Access Compliance Report

Public Rights-of-Way

Intersection ID: 49691	Main Street: OLIVIA_VIEW_CT	Cross Street: ALEXANDRA_ALLEY_DR	Location: N
ADA ID: 3AF56945488D	Ramp Type: PerpDiag	Initial Pass/Fail: Fail	Overall Compliance: No
Severity Score: 12.5			
Codes/Mitigation Info/Possible Solution		Field Measurements/Component Compliance

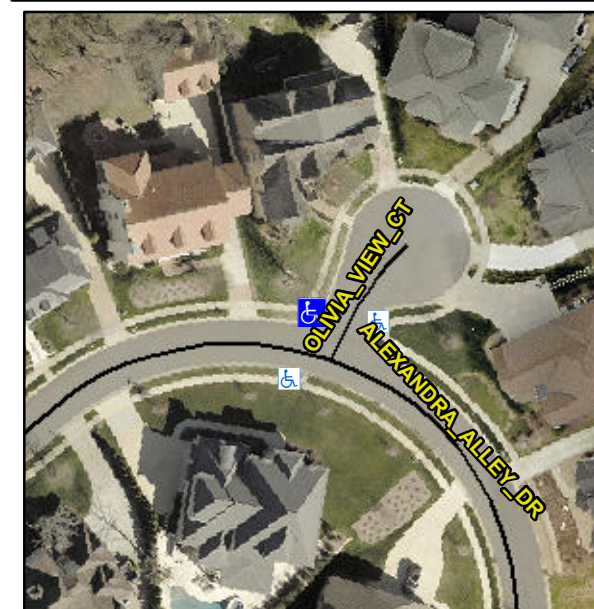
Not Found, R304.2.2

Compliance	Description	Data	Compliance	Description	Data
N/A	Ramp Length (in)	50.5	No	Ramp Slope (%)	10.2
Yes	Ramp Width (in)	48.0	Yes	Ramp XSlope (%)	1.7
N/A	Flare Type LT	N/A	N/A	Flare Type RT	N/A
N/A	Flare Slope LT (%)	N/A	N/A	Flare Slope RT (%)	N/A
N/A	Flare Traversable LT?	N/A	N/A	Flare Traversable RT?	N/A
N/A	Landing Length (in)	N/A	N/A	DWS Provided?	N/A
N/A	Landing Width (in)	N/A	N/A	DWS Contrast?	N/A
N/A	Landing Slope (%)	N/A	N/A	DWS Length (in)	N/A
N/A	Landing X Slope (%)	N/A	N/A	DWS Full Width?	N/A
N/A	Landing Curb? (Y/N)	N/A	N/A	DWS Offset (in)	N/A
N/A	Shared Landing?	N/A			
N/A	Gutter Ponding?	N/A	N/A	Gutter Slope (%)	N/A
N/A	Gutter Lip Ht (in)	N/A	N/A	Gutter X Slope (%)	N/A
N/A	Painted X Walk1?	No	N/A	Painted X Walk2?	No
	X Walk 1 Direction	To SW		X Walk 2 Direction	To SE
N/A	X Walk 1 Width (in)	N/A	N/A	X Walk 2 Width (in)	N/A
	X Walk 1 Slope (%)	0.2		X Walk 2 Slope (%)	0.5
	X Walk 1 X Slope (%)	1.4		X Walk 2 X Slope (%)	1.3

Remove & Replace Curb Ramp With Two New Directional Ramps or Equivalent.
